APPLICATION NO.	FILING DATE	FIRST NAMED INVENTOR	ATTORNEY DOCKET NO.	CONFIRMATION NO.
10/597,200	07/14/2006	Jong-Lam Lee	P2381US00	7656
58027 7590 02/25/2010 H.C. PARK & ASSOCIATES, PLC 8500 LEESBURG PIKE SUITE 7500 VIENNA, VA 22182			EXAMINER NGUYEN, THINH T	
			ART UNIT 2818	PAPER NUMBER
			NOTIFICATION DATE 02/25/2010	DELIVERY MODE ELECTRONIC

Office Action Summary	Application No. 10/597,200	Applicant(s) LEE, JONG-LAM	
	Examiner THINH T. NGUYEN	Art Unit 2818

DETAILED ACTION

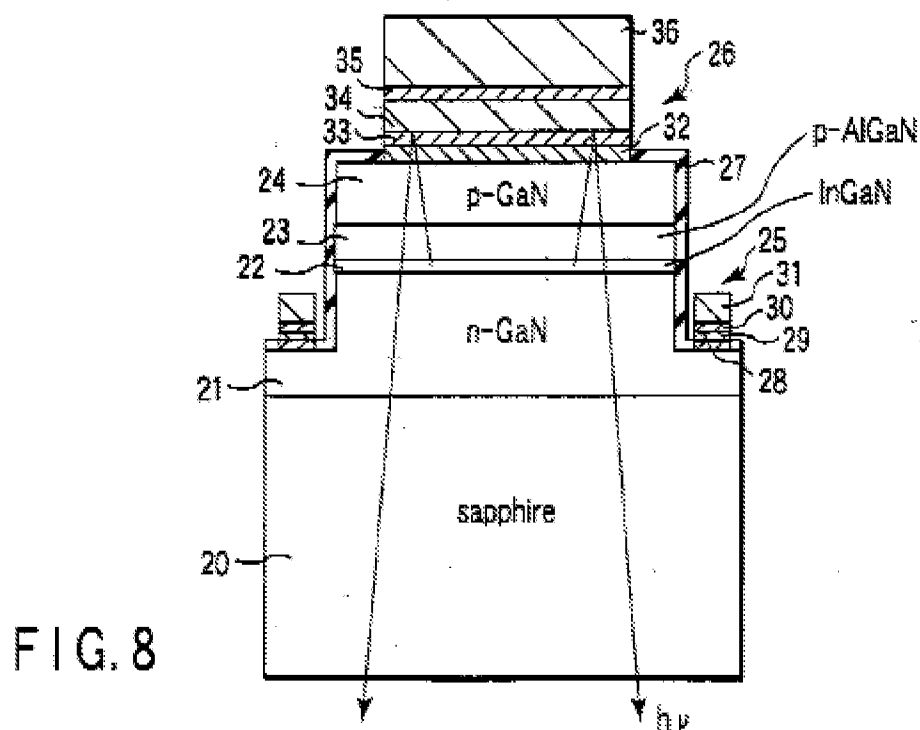
6. Claims 1-6 are rejected under 35 U.S.C. §102(b) as being anticipated by Okazaki et al.(US patent Application publication 2002/0014630) thereafter Okazaki 630. .

With regard to claim 1, Okazaki 630. discloses (the abstract, fig 8) a gallium nitride-based III-V group compound semiconductor device comprising (for the P-side electrode in fig 8) :a gallium nitride-based semiconductor layer(fig 8 layer 24) ; a p-type ohmic electrode layer formed on the gallium nitride-based semiconductor layer,wherein the p-type ohmic electrode layer comprises a contact metal layer (layer 32 or 33 fig 8, or combined layer 32 and 33, paragraph [0097].), a reflective metal layer(fig 8 layer 34, the abstract, paragraph

[0097], paragraph [0098]) and a diffusion barrier layer. (fig 8, layer 35, the abstract, paragraph [0098]), the reflective metal layer (fig 8 layer 34) being disposed between the contact metal layer (fig 8 layer 32 or 33 or combined layer 32+33) and the diffusion barrier layer (fig 8 layer 35, paragraph [0097], [0098])

With regard to claim 2, Okazaki 630 discloses a Gallium Nitride device wherein the p-type ohmic electrode layer further comprises at least one bonding metal layer (fig 8, the abstract , paragraph [0097]). for the P-side electrode (layer 36, fig 8, paragraph [0097], paragraph [0098]).

With regard to claim 3, Okazaki 630 discloses a Gallium Nitride device (fig 8 layer 28, layer 29 , layer 30 , and layer 31, paragraph [0097]),. wherein the p-type ohmic electrode layer is formed by sequentially laminating the contact metal layer (fig 8, combined layer 32+33) the reflective metal layer,(fig 8 layer 34) the diffusion barrier layer (fig 8 layer 35) , and the bonding metal layer fig 8 layer 36)

Note that Okazaki 630 discloses that the contact metal layer 32 is made of Ni (fig 8, layer 32,the abstract, paragraph[0097]) .

With regard to claim 5, Okazaki 630 discloses a Gallium Nitride device wherein the reflective metal layer comprises at least one of Al and Ag (fig 8 , layer 34 , paragraph [0097],[0098]) note that Okazaki 630 discloses that layer 34 is made of Aluminum..

With regard to claim 12, Okazaki 630 discloses (fig 8 ,the abstract) the invention of a gallium nitride-based III-V group compound semiconductor device wherein the contact metal layer comprises a first layer and a second layer (1st contact layer 32 and 33, fig 8, paragraph [0097][0098],[0134]), and wherein the first layer (fig 8 layer 32 paragraph

[0097][0098],[0134]),) comprises one of Ni, Ir, Pt, Pd, Au, Ti, Ru, W, Ta, V, Co, Os, Re, and Rh, the second layer (fig 8 layer 33 paragraph [0097][0098],[0134]), comprises one of Ni, Ir, Pt, Pd, Au, Ti, Ru, W, Ta, V, Co, Os, Re, and Rh, and the first layer and the second layer do not comprise the same material.

With regard to claim 13, Okazaki 630 discloses (fig 8 ,the abstract) the invention of a gallium nitride-based III-V group compound semiconductor device wherein the ohmic electrode layer further comprises at least one bonding metal layer (fig 8 ,layer 36) disposed on the diffusion barrier layer(fig 8 layer 35), the diffusion barrier layer (fig 8 layer 35) being disposed between the reflective layer (fig 8 layer 34) and the at least one bonding metal layer (fig 8 layer 36).

SLATER 721 DISCLOSURES

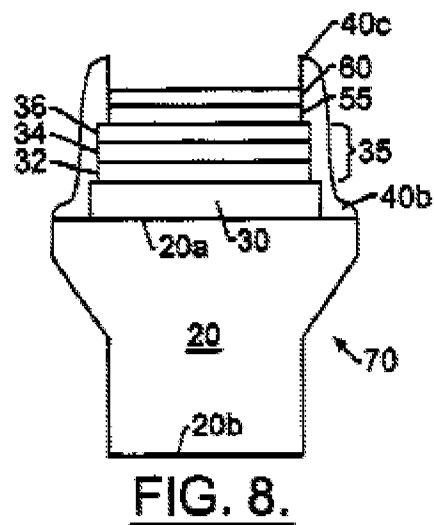
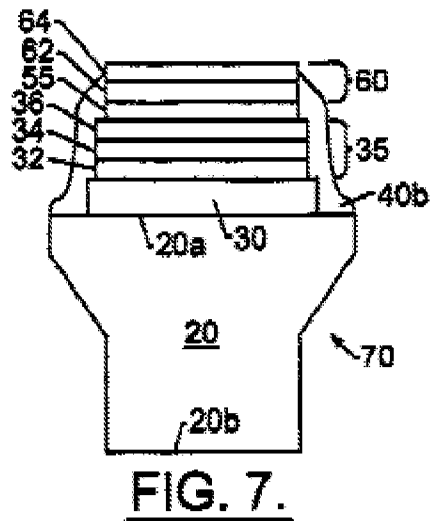
7. Claims 1- 7 are rejected under 35 U.S.C. §102(b/e) as being anticipated by Slater Jr et al. al. (US patent Application publication 2003/0015721) thereafter Slater 721.

With regard to claim 1, Slater 721 discloses (the abstract, fig 8,fig 7) a gallium nitride-based III-V group compound semiconductor device comprising; a p-type ohmic electrode layer (paragraph [0022] , Slater 721 discloses that all of his embodiments are complementary ; i.e. include p-type or n-type) formed on the gallium nitride-based semiconductor layer(fig 7,fig 8, layer 30) wherein the p-type ohmic electrode layer comprises a contact metal layer (layer 32 fig 8, fig 7) a reflective metal layer(fig 8,fig 7 layer 34, the abstract, paragraph [[0041]and a

diffusion barrier layer.(fig 8, fig 7 layer 36, the abstract, paragraph [0041], the reflective metal layer (fig 8 layer 34) being disposed between the contact metal layer (fig 8,fig 7) layer 32) and the diffusion barrier layer (fig 8 layer 36)

With regard to claim 2, Slater 721 discloses a Gallium Nitride device wherein the p-type ohmic electrode layer further comprises at least one bonding metal layer (fig 8,],paragraph [0098]).

With regard to claim 3, Slater 721 discloses a Gallium Nitride device (fig 7 combined layer 55+60, fig 8 combined layer 55+60)), wherein the p-type ohmic electrode layer is formed by sequentially laminating the contact metal layer (fig 8,fig 7 layer 32,) the reflective metal layer,(fig 8,fig 7 layer 34) the diffusion barrier layer (fig 8 ,fig 7 layer 36) , and the bonding metal layer fig 8 combined layer 55+60,fig 7 combined layer 55+60)

With regard to claim 5, Slater 721 discloses a Gallium Nitride device wherein the reflective metal layer comprises at least one of Al and Ag (fig 8 , fig 7 layer 34 , paragraph [0041]note that Slater 721 discloses that layer 34 can be made of Aluminum or silver..

With regard to claim 7, Slater 721 discloses the invention of a gallium nitride device wherein the bonding metal layer comprises first and second bonding metal layers, said first bonding metal layer (,fig 8 , layer 55, fig 7 layer 62 or 55) comprising at least one of Ni, Cr, Ti,

Pd, Ru, Ir, Rh, Re, Os, V, and Ta, said second bonding metal layer (fig 8 layer 60, fig 7 layer 62 or 64) comprising at least one of Au, Pd, and Pt. (paragraph [0049],[0058],[0059])
